Expansion Project at North Point (EF III)

**SUPPLEMENT TO FINAL DEVELOPMENT  
PLAN APPLICATION**

24 July 2017

## **COMMENTS FROM PLANNING BOARD**

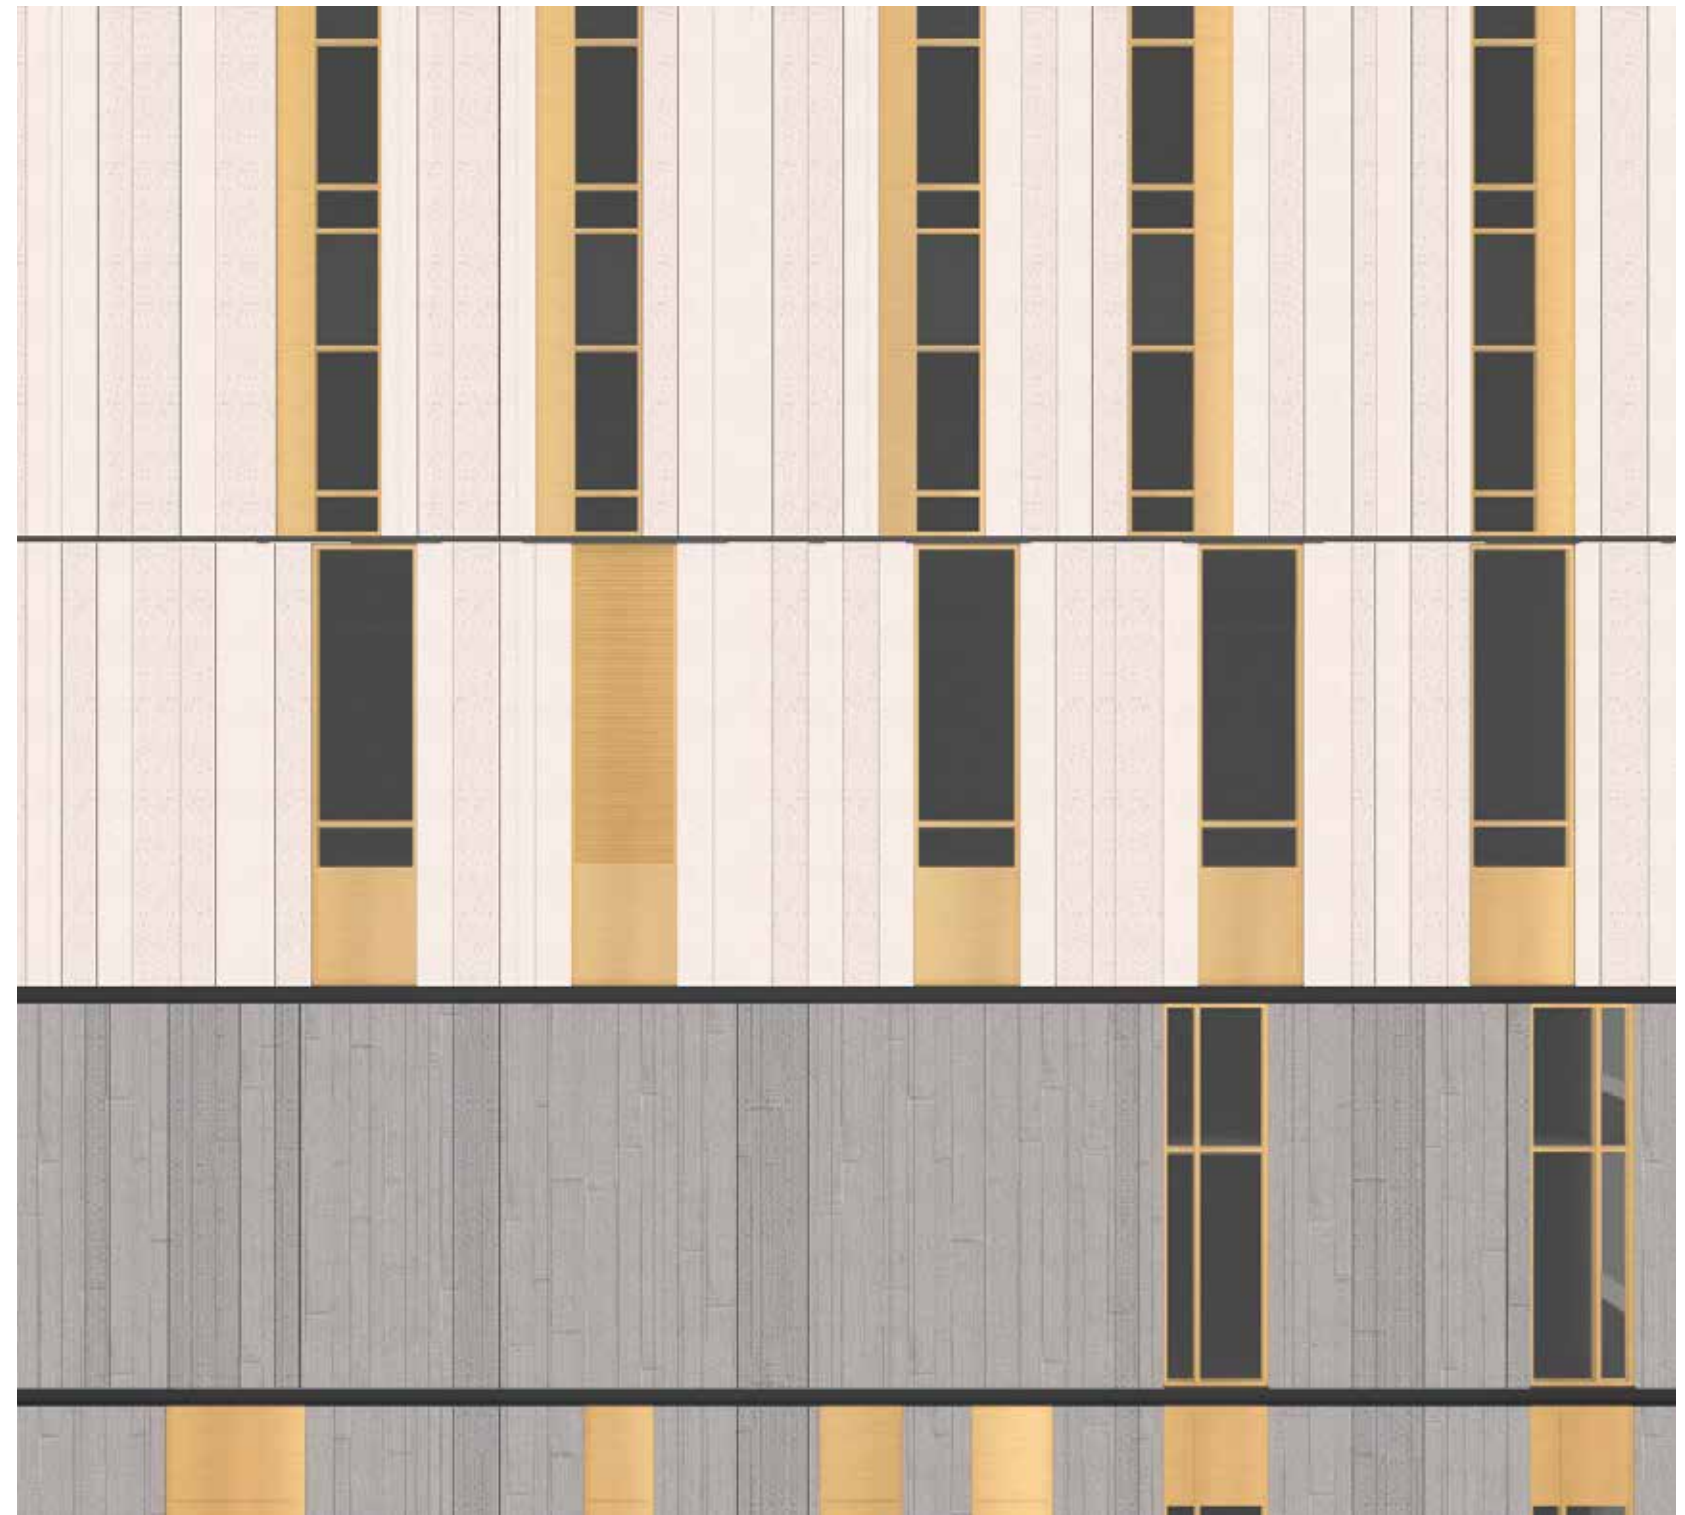
Explore alternative sizes, shapes and architectural treatment of the exterior support column in the front façade

The dimension of the corner column along North Point Boulevard has been adjusted from a diameter of 2'-0" to 3'-9" as to provide stronger visual support of the building mass above. Additionally, the color and surface of the column has been developed to match the precast at the building base, with an inset reveal at the top and bottom, to give it a stronger visual interest.

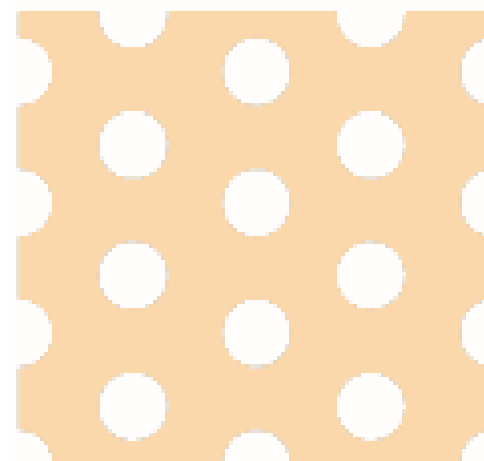
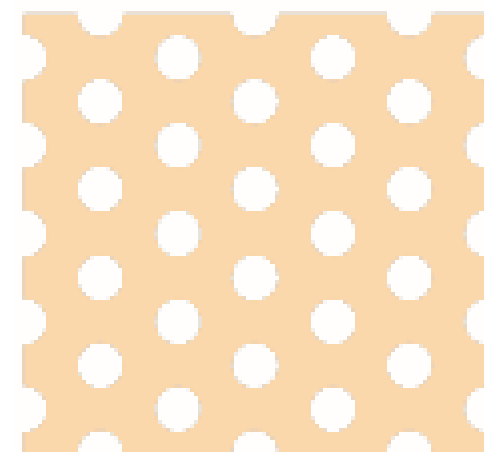
Improve the design of the rooftop mechanical screen so as to completely screen all the mechanicals if possible.

The penthouse roof and rooftop screen wall are 16'-6" in height. The screen wall design consists of a painted corrugated metal panel with 23% perforation to promote ventilation. Perforation also helps reduce the load from the wind needed for the support structure. The open percentage can be achieved through a variety of means. The perforation will be chosen to minimize the transparency by studying the stagger and size of the holes. Corrugating the panels help provide rigidity and greater opacity.

All rooftop mechanical equipment is lower in height and will be screened from view. The exception to this is the cooling tower which is 20'-0" tall. The cooling tower remains screened from view at grade as demonstrated in the range of on grade images.

In order to minimize the mechanical unit views, we have elected to paint the units the same color as the screen.

View from the Gilmore Bridge - Current Proposed View

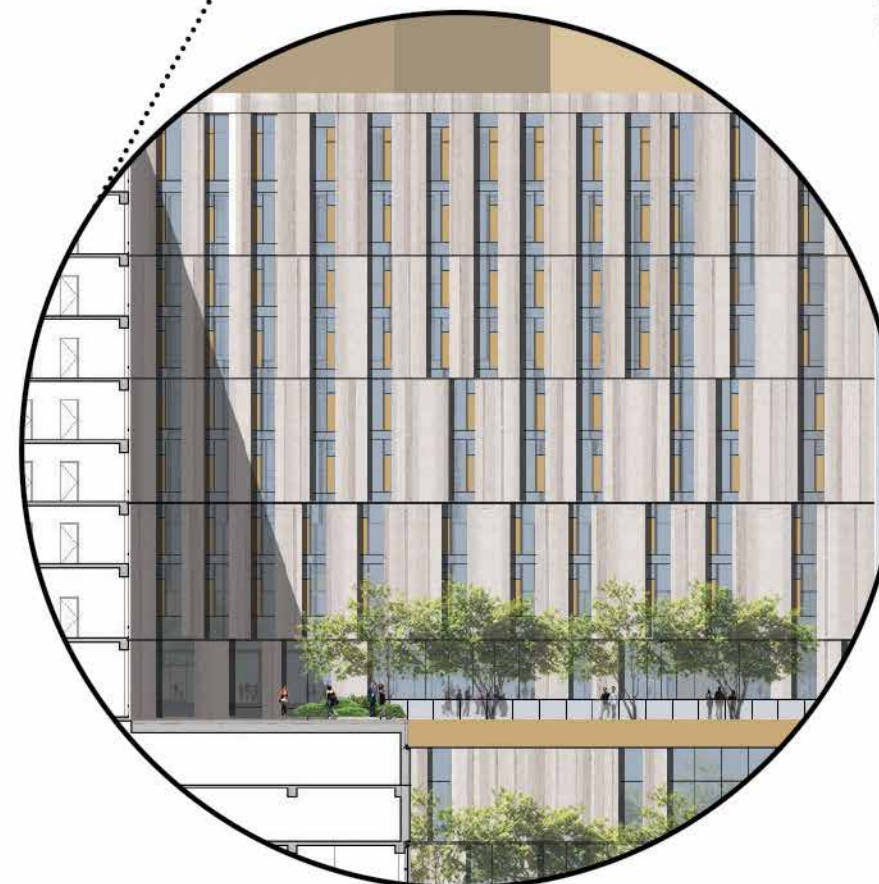
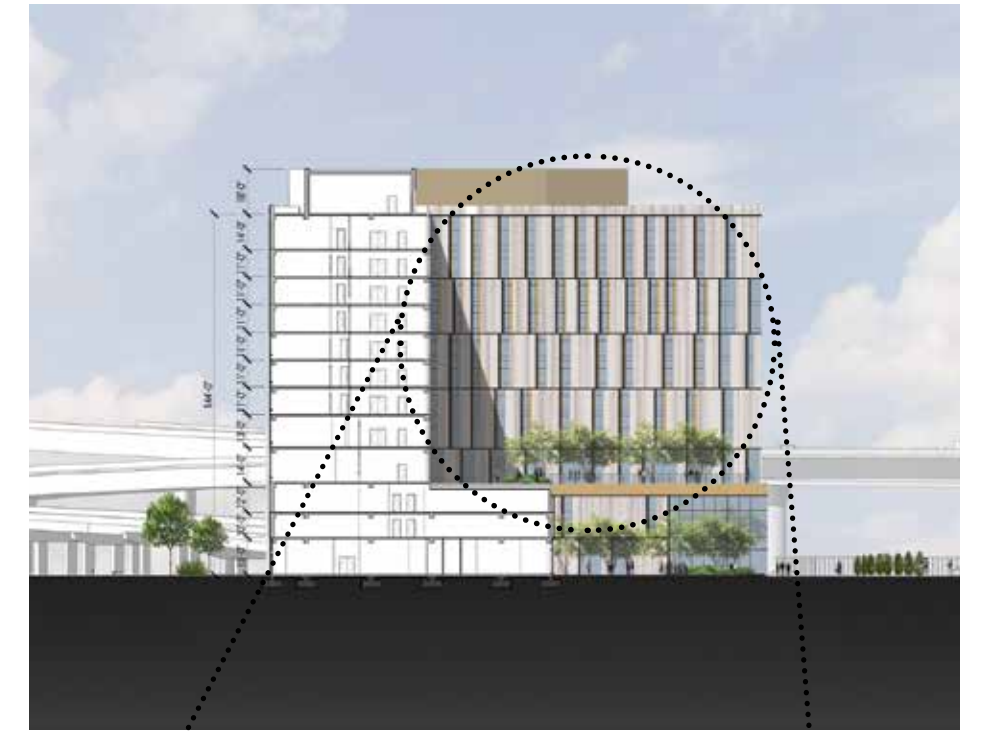
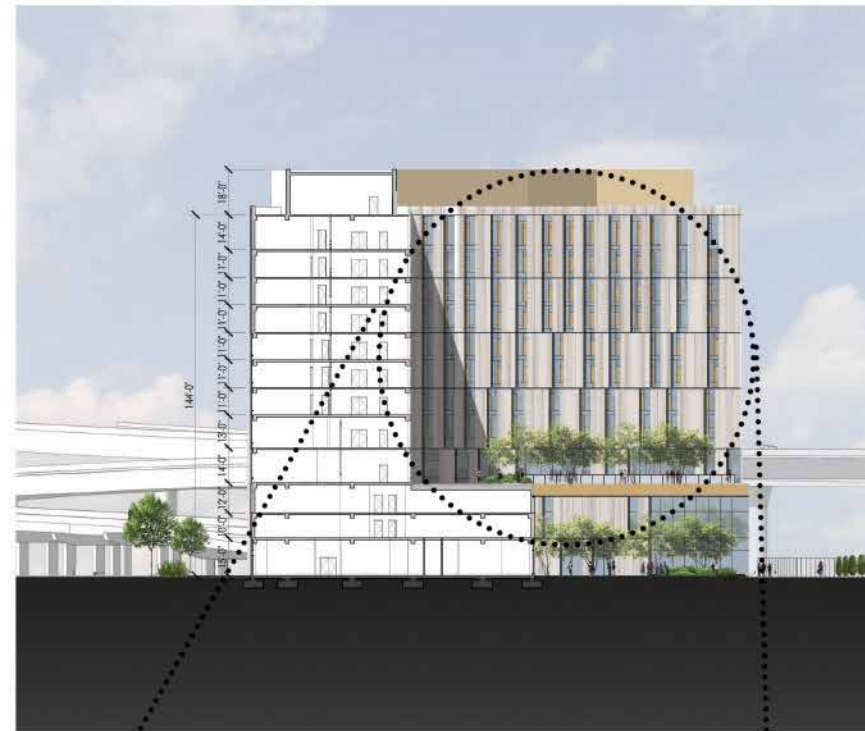
Improve the visual character of the blank wall at the north corner of the building.

We have studied a range of options for creating more design interest at the NW corner of the building. We think the most effective solution is to let the accent color and material of the penthouse wall extend down to the roof transition above the base, effectively reducing the visual mass of the building. This also alludes to the original concept for the EF II project, where the color pool of the penthouse appears to spill down the façade. Keeping the end wall as solid allows us to not only maintain the braced frames, but express the residential volume of the north façade.

The difference between base, tower and penthouse is expressed through different pre-cast finishes and metal cladding to the penthouse. This separation is about making the building legible, expressing differing functions inside as you view the building from street to sky. The small break in the elevation as viewed from the highway provides a different vertical articulation of the building volumes and is highlighted by a metal clad reveal.

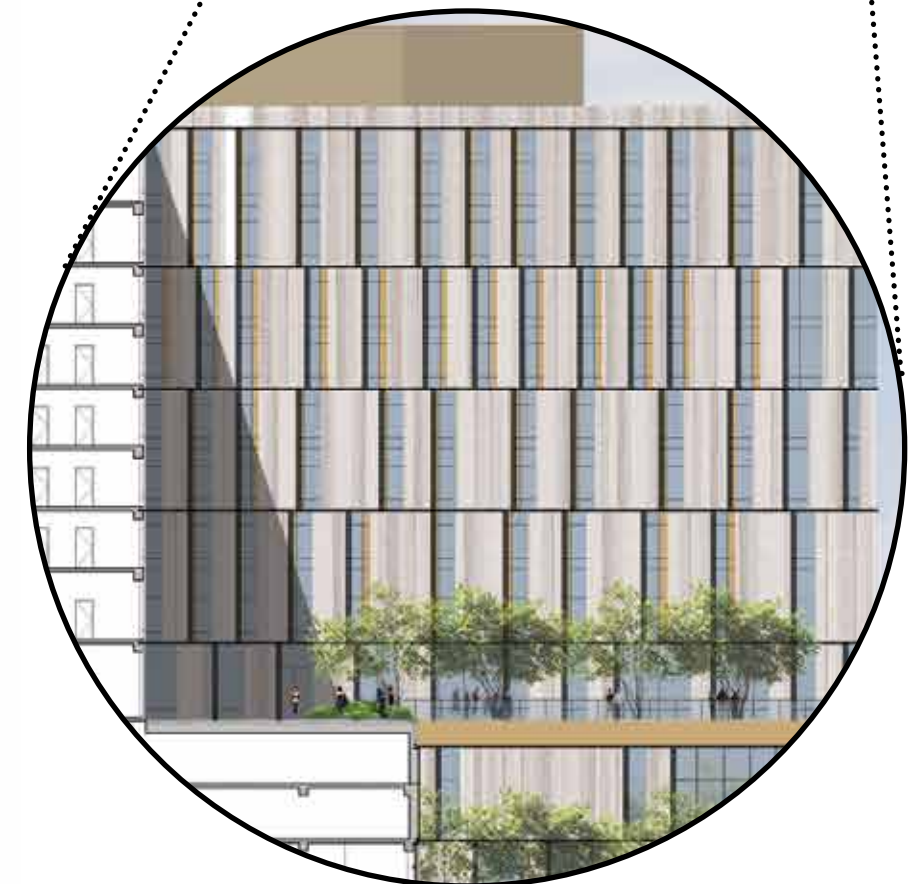
Explore using a similar façade treatment for both the internal elevations and the front elevations of the building, with an emphasis on doing more with publicly visible façades.

We agree with your comment and have adjusted the facade treatment of the internal building elevations to match the exterior building elevations by creating more floor to floor stagger in window location.

Image 1 - Dorm Room Interior

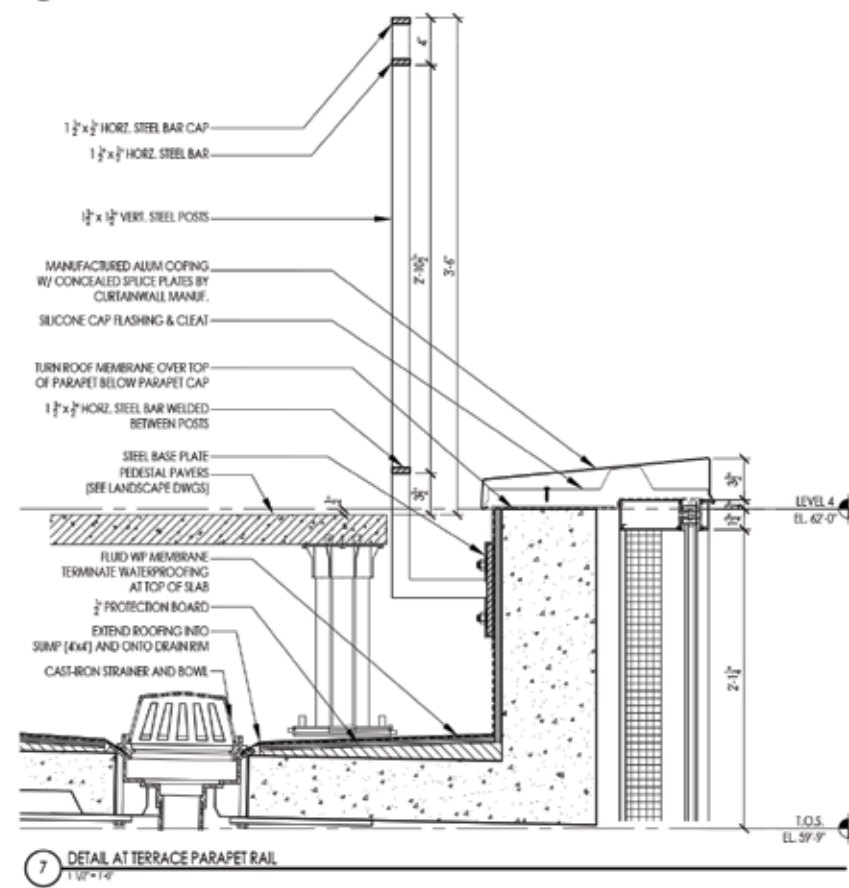
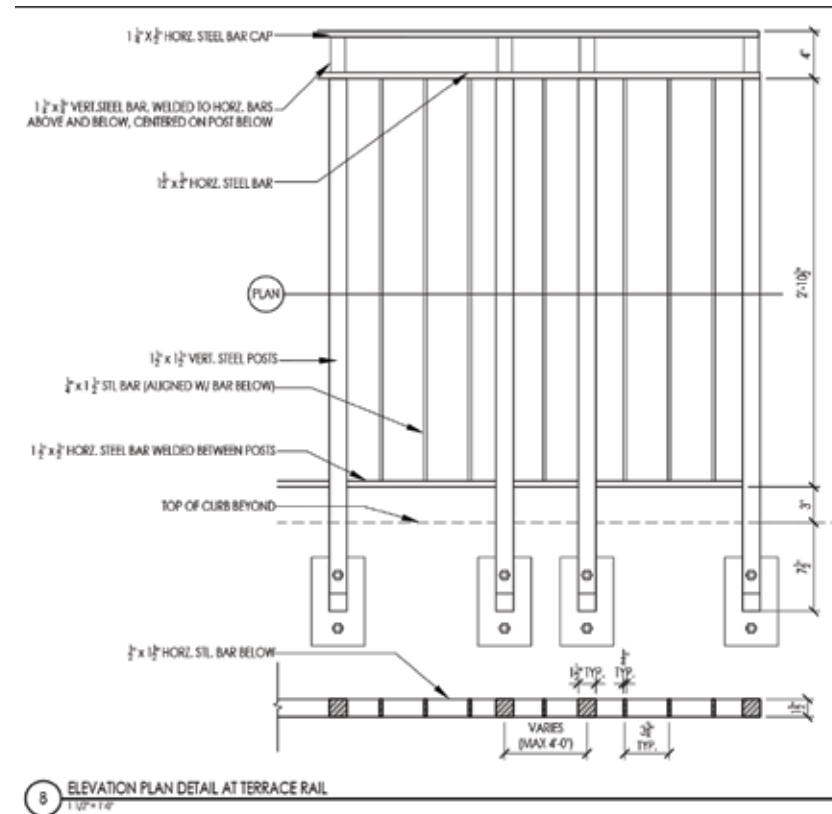
Consider if there is adequate width of windows in the residential areas of the building, and provide an interior rendering of a dorm room.

The windows within the residence units are 4'-6" W 8'-3"H. As illustrated in the rendered interior view we believe the size is appropriate the room function and give plentiful access to natural light, views, and ventilation.

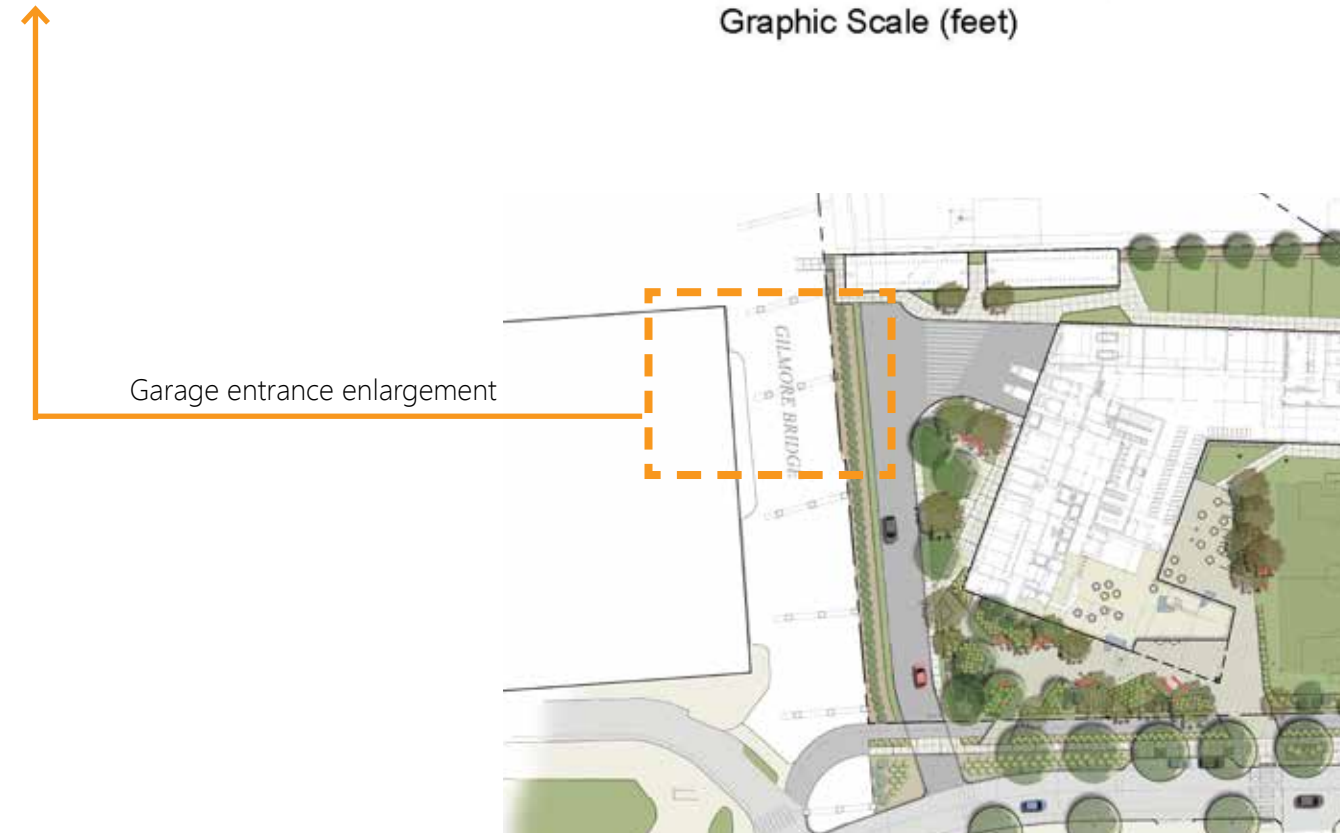
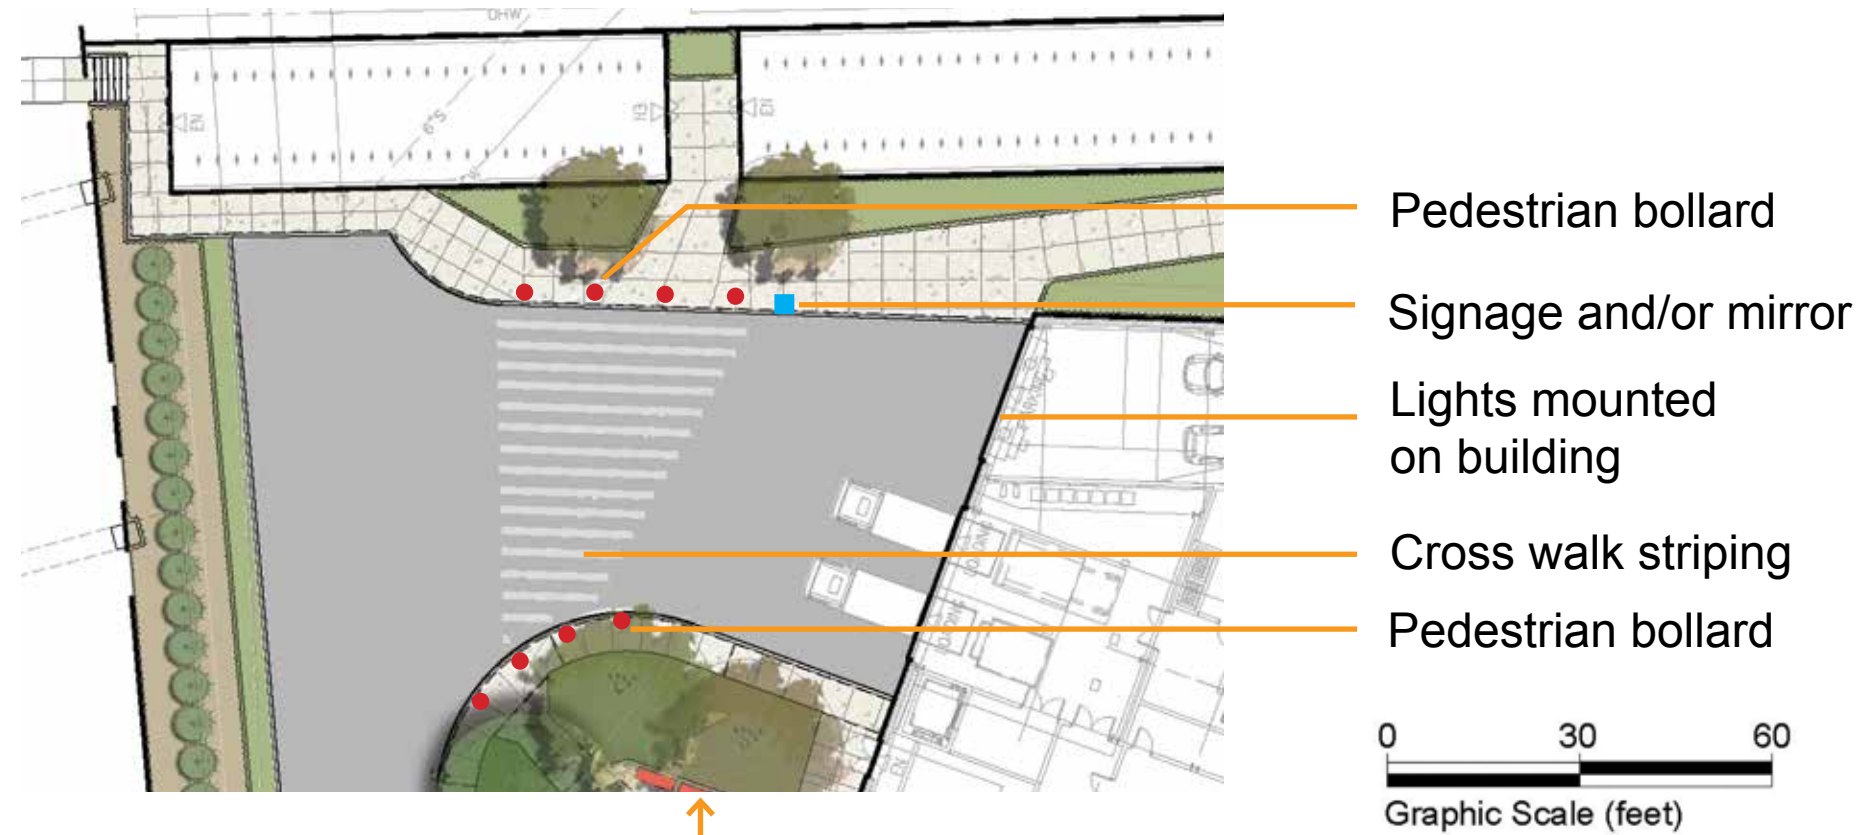
Provide details for reducing conflict between vehicles and bicycles near the garage entrance and bike sheds.

EF is proposing a number of methods to reduce conflict between vehicles and bicycles near the garage entrance and bike sheds, including:

- Audible signals to pedestrians and bikers when vehicles are entering/exiting the building
- Safety lighting to ensure proper visibility at night
- Mirrors for drivers exiting the garage to see pedestrians and bikers on either side of the building
- Bollards installed at the crosswalks to signal to pedestrians and bikers that the use is changing
